**Vogtle Project**

NRC DOCKET NUMBERS 50-424 AND 50-425  
CONSTRUCTION PERMIT NUMBERS CPPR-108 AND CPPR-109  
VOGTLE ELECTRIC GENERATING PLANT - UNITS 1 AND 2  
REQUEST FOR ADDITIONAL INFORMATION: GENERIC LETTER 85-12

VEGP SUPPLEMENTAL INFORMATION CONCERNING RESPONSE TO  
GENERIC LETTER 85-12

**Figure 1. MINIMUM INDICATED PRESSURIZER LEVEL FOR RCP RESTART**

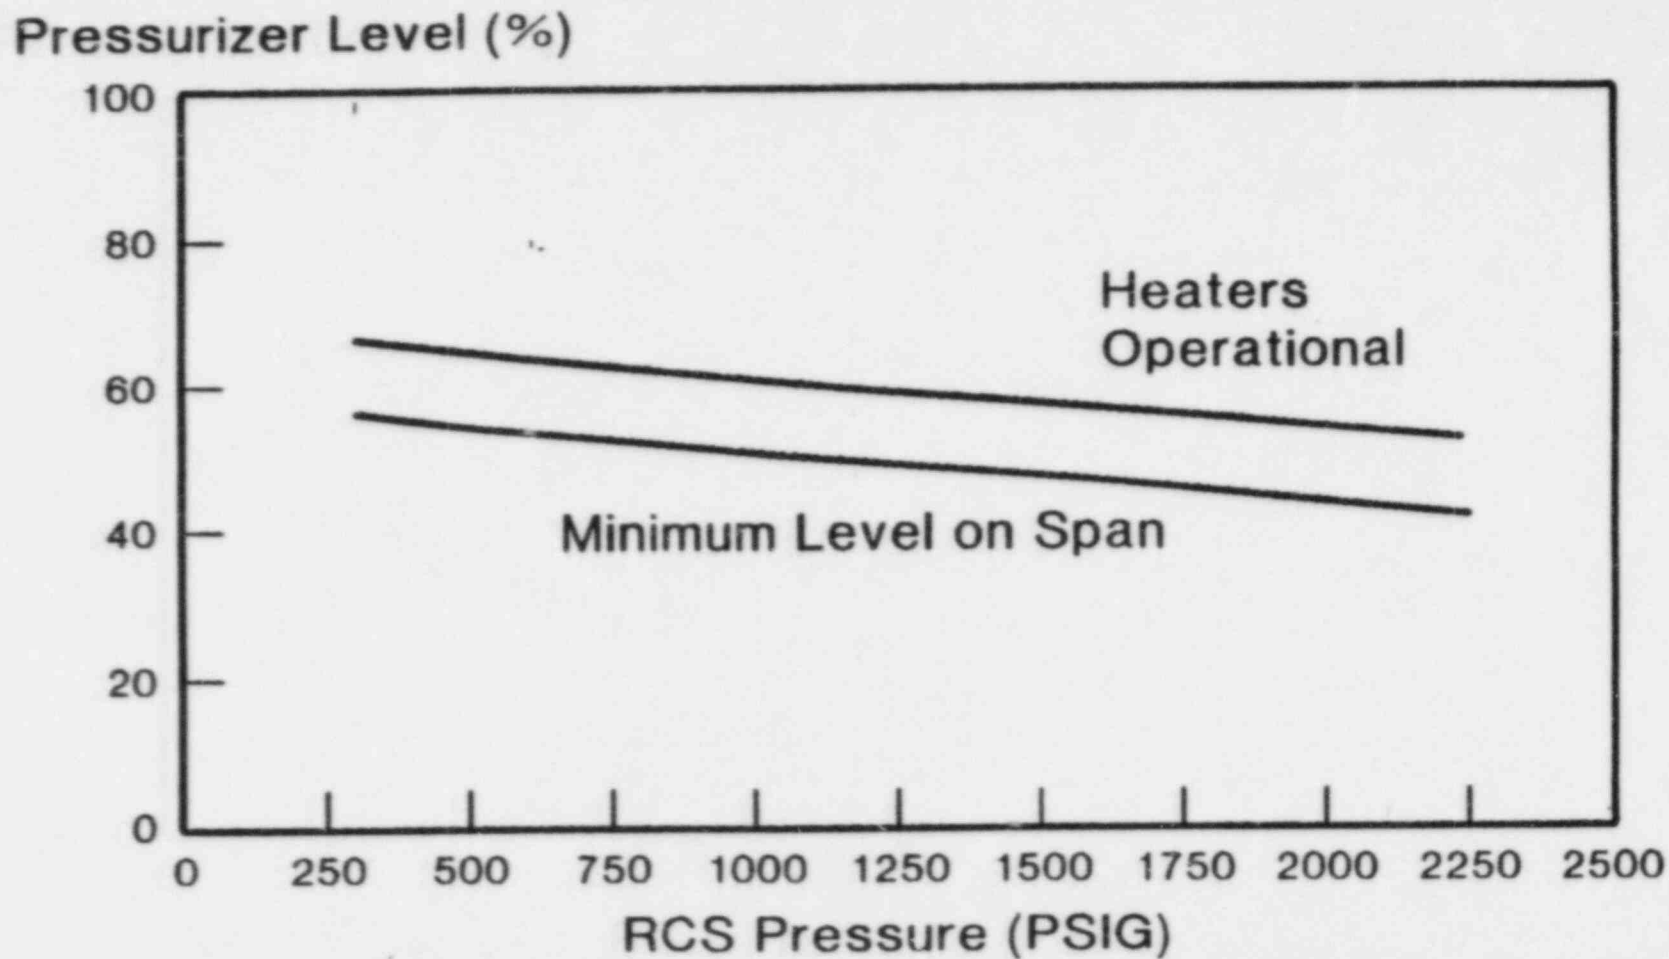
- C2. STAFF EVALUATION - The licensee has presented a listing of selected procedures, most of which are stated to be based upon the WOG Guidelines. This list appears to be sufficient. It would be helpful to briefly describe the technical requirements to be met for restart.

Figure 3 presents the minimum indicated pressurizer level required for Vogtle before starting an RCP to ensure that an indicated level will remain after pump restart with the upper head region voided. The level necessary to maintain pressurizer heaters operational is also shown in Figure 1. The results in Figure 1 include all an allowance for the pressurizer level instrument uncertainty. The effects of pressure on the calibration of the level indication are also included in these results. As demonstrated, pressurizer level would remain on span for all primary pressures following

RCP restart with an indicated level greater than 57 percent. An initial level greater than 67 percent would be required to ensure that the pressurizer heaters would remain available.

EFFECT OF PUMP TRIP TIME ON PEAK CLADDING TEMPERATURE FOR WESTINGHOUSE 3-LOOP PLANT  
(PREPARED FROM TABLE 3.2-1 OF WCAP-9584)

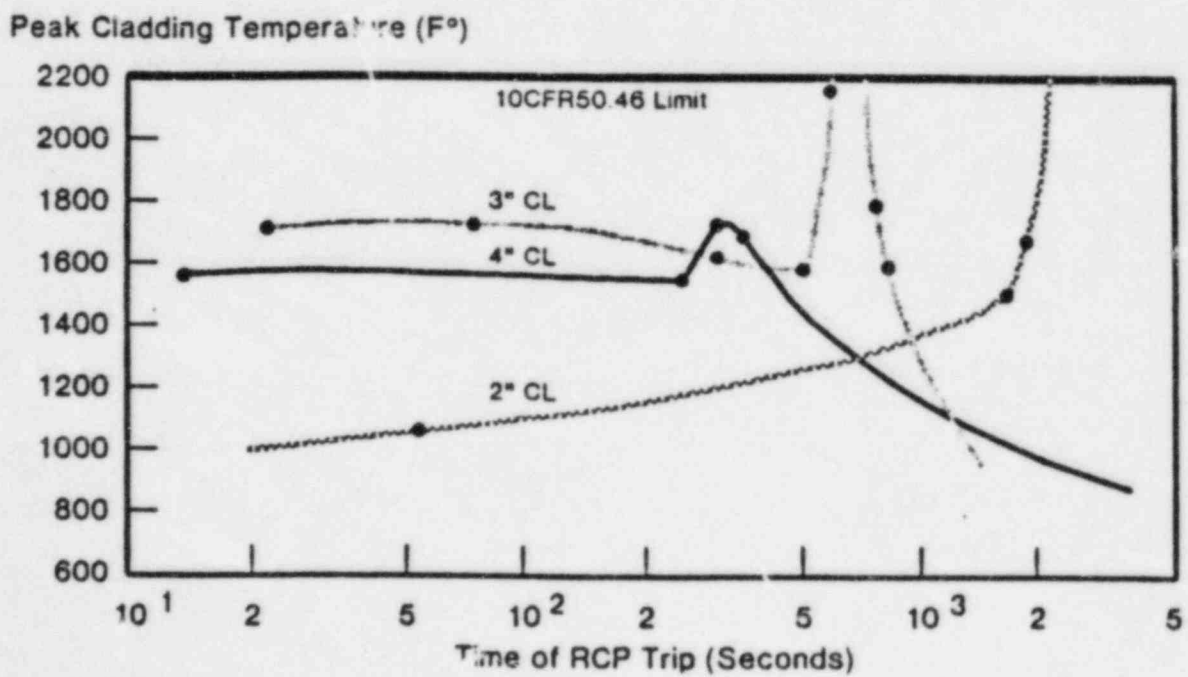
- C1. STAFF EVALUATION - References for training are provided as is a list of training topics. However, the applicant response is general and does not address the above identified points, nor does the response establish that the applicant has an understanding of the need to trip RCPs as contrasted to keep them running.

Westinghouse has determined (WCAP-9584) that approximately 10 minutes are available for trip of the RCPs following the worse case small break LOCA. Trip of the RCPs within this time frame will prevent peak clad temperatures from exceeding 2200°F.

Verifying that the RCPs would be tripped within the 10 minute time frame specified by Westinghouse, was accomplished by the EOP Validation performed on the Vogtle Simulator. Two different teams of operator and controllers performed various LOCA scenarios. The average time period for the operator to trip the RCPs using the trip criteria was 155 seconds (2½ minutes) from the initiation of the LOCA event, with 15 seconds being the shortest time period and 4 minutes the longest. No concerns were expressed about using the RCP Trip Criteria in the debriefings with operators following the scenario runs. No instances occurred, during the runs, where the RCP trip was inadvertently omitted, nor was there any instance where the RCPs were unnecessarily tripped.
